# PREVOST

## WARRANTY BULLETIN

**WB18-03**

DATE :	February 2018	SECTION :	06 ELECTRICAL
EXPIRATION:	February 2020		
SUBJECT :	<b>EQUALIZER REPLACEMENT</b>

Figure 1

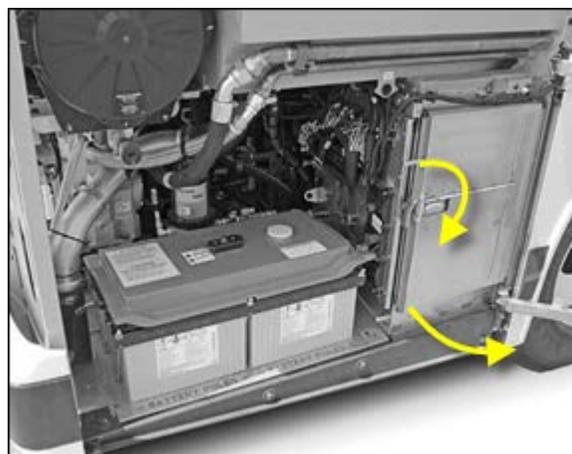
1. At the rear curbside of the vehicle, open the main power compartment.

Figure 2

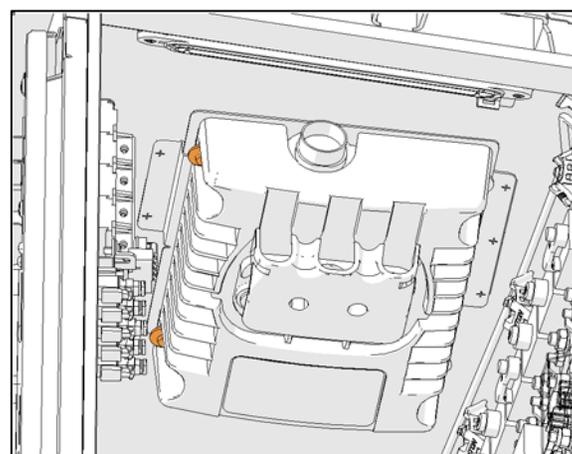
2. The battery equalizer is located in the upper section of the compartment.

Figure 3

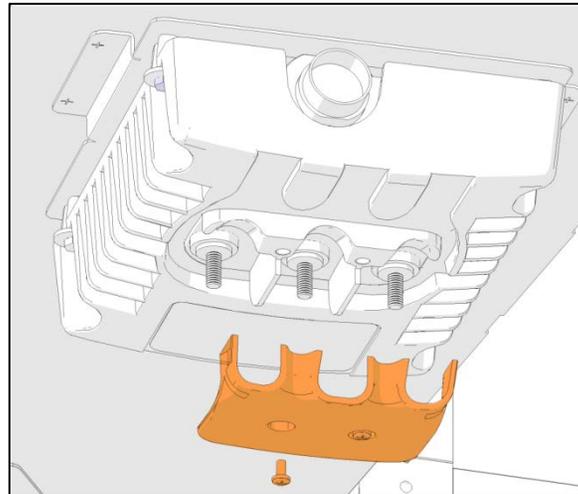
3. Remove cable cover.
4. Keep cover and hardware.

Figure 4

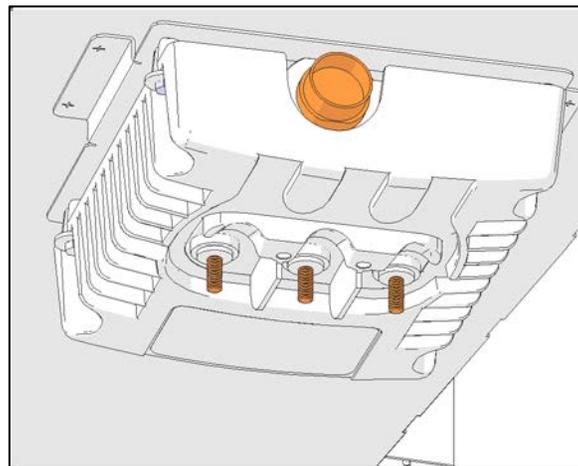
5. Unplug all electrical connections.
6. Re-install the nuts on the studs (3x).

Figure 5

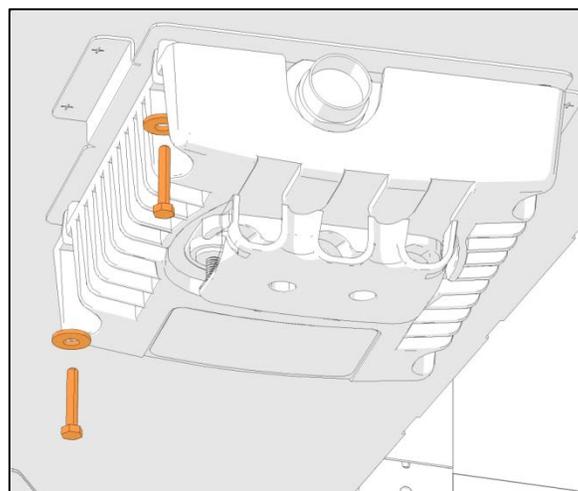
7. Remove old equalizer. Keep hardware.
8. Replace cable cover on old equalizer.
9. Discard old equalizer.
10. Install new equalizer with reserved hardware.

Tighten to **68 lb-in (7.7 Nm)**

If hardware is lost or damaged, order:

4x 502888 Screw M6 x 35

4x 5001848 Belleville Washer

Figure 6

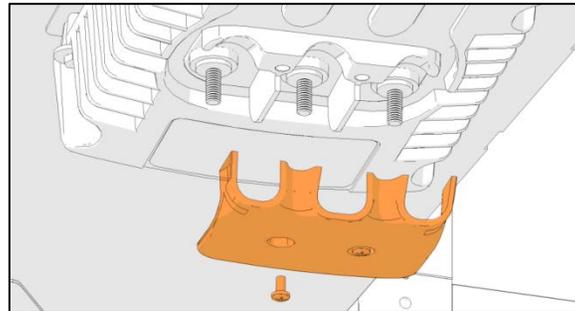
11. Remove the cable cover.
12. Keep cover and hardware.

Figure 7

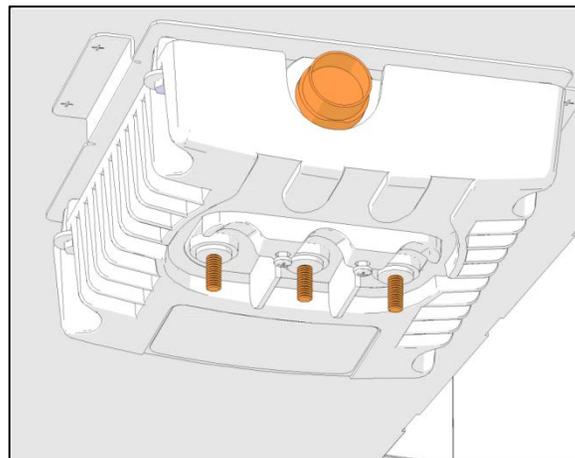
13. Make all electrical connections. Use hardware supplied with equalizer.
14. Tighten stud nuts to 100 lb-in (3x)

Figure 8

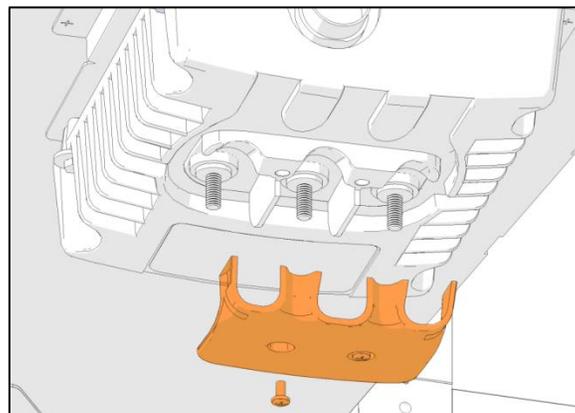
15. Replace cable cover.
